## **JOINT REGIONAL PLANNING PANEL**

<b>JRPP No</b>	<b>2013HCC002 DA</b>
<b>DA Number</b>	<b>DA/251/2013</b>
<b>Local Government Area</b>	<b>Lake Macquarie City Council</b>
<b>Proposed Development</b>	<b>Home Improvement Centre - Staged Development (Stage 1A) Bulky goods Centre and Restaurant, Landscaping and Signage</b>
<b>Street Address</b>	<b>Lot 10 DP 1013486, Lot 11 DP 1013486, Lot 12 DP 1013486, Lot 13 DP 1013486, Lot 14 DP 1013486  4B South Street, Windale</b>
<b>Applicant</b>	<b>Hydrox Nominees Pty Ltd</b>
<b>Owner</b>	<b>Lake Macquarie City Council</b>
<b>Capital Investment Value</b>	<b>\$38,435,000.00</b>
<b>Recommendation</b>	<b>Approval with Conditions – Development Consent</b>
<b>Report by</b>	<b>Brian Gibson Senior Planner Lake Macquarie City Council</b>

## 1 PRÉCIS

**Figure 2**

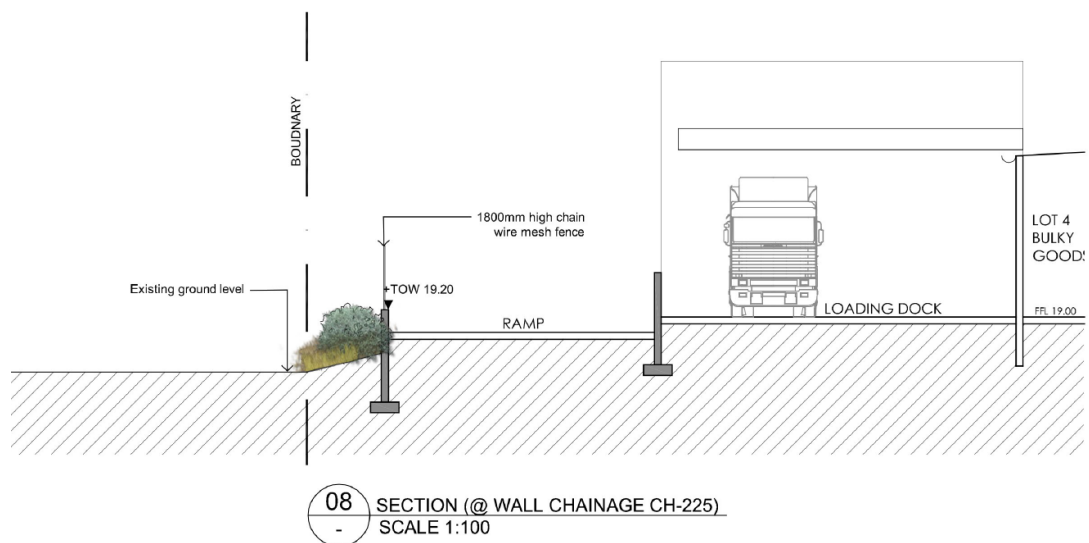
- ii. Issues exist however with the northern section of the proposed landscape buffer at the rear of the Bulky Good Tenancies 9-13 (Section 5 Rear Elevation [Figure 2] & Section 8 Elevation 5 [Figure 3]) as no tree planting is nominated to abut the PCYC site. This is not supported and does not reflect outcomes discussed in the previous meeting with the proponent.

- iii. No tree retention is nominated as per recommendation of the preliminary Arborist report and as was discussed at the meeting with the Applicant and Consulting Landscape Architect. Recommended conditions will address this issue.
- iv. A number of additional modifications to the landscape plans are recommended from a landscape, streetscape and visual perspective. These include changing areas of turf to mulch and mass plantings, changes to boundary fence alignment and styles, landscaping within the car park areas, and additional tree plantings. These changes will be included as part of the recommended conditions.

Figure 5

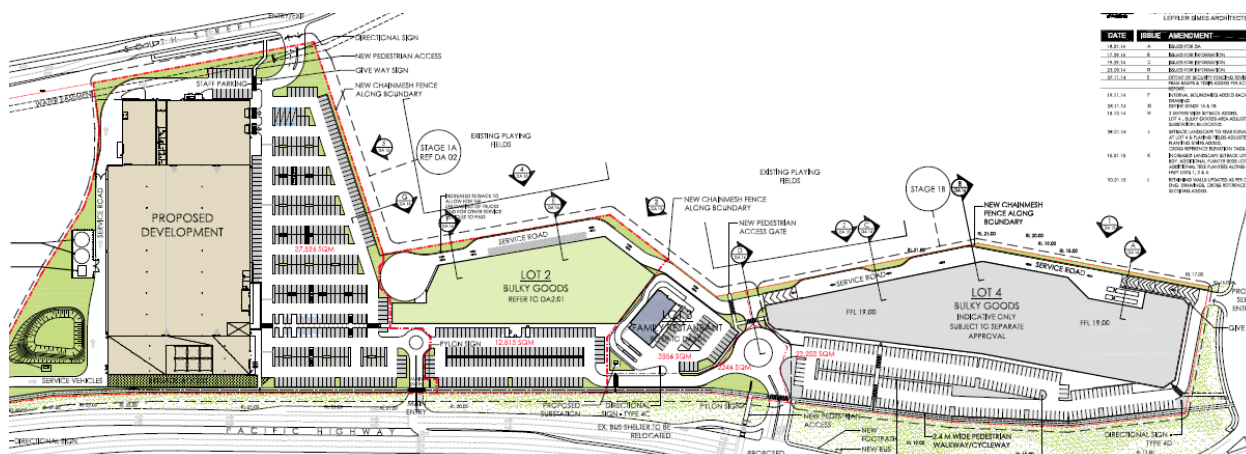
Note, the reference to 'Lot' above is as used by the applicant in relation to Figure 5 below. The 'Lot' reference does not apply to any proposed subdivision as part of this application rather being a component/section of the site for construction purposes.

Figure 5 is an excerpt from the Overall Site Plan that highlights the breakup of the development into Lots 1, 2, 3 & 4.

Figure 6

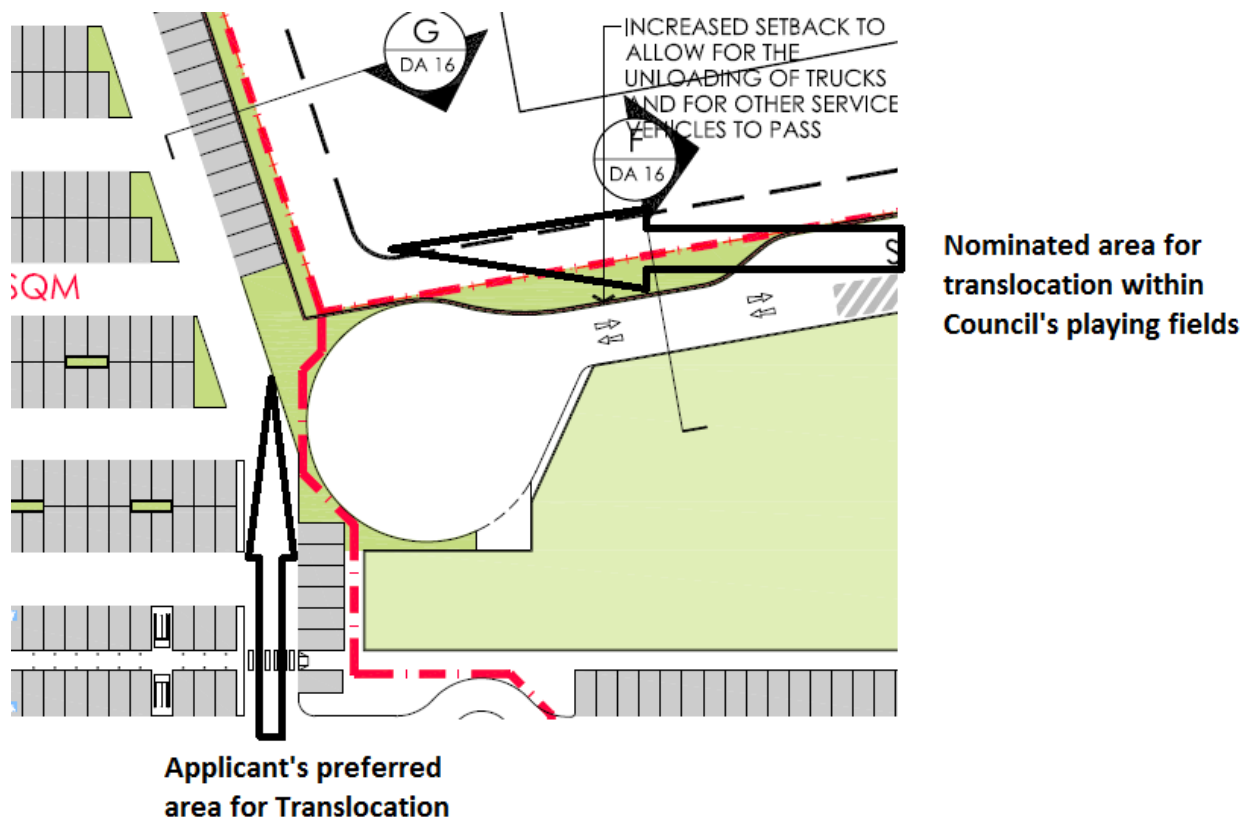
The applicant advised, under the direction of a suitably qualified professional, the intent to translocate the 10 stems of the *Grevillea parviflora* (subsp) *parviflora* onto Masters Land, if possible, in the landscaped area on the south-western side of the turning area of the Service Road. The applicant further advised that if not possible the translocation would occur on Council land in the vicinity of the playing fields.

Refer to Figure 6 below for details of the potential translocation areas.
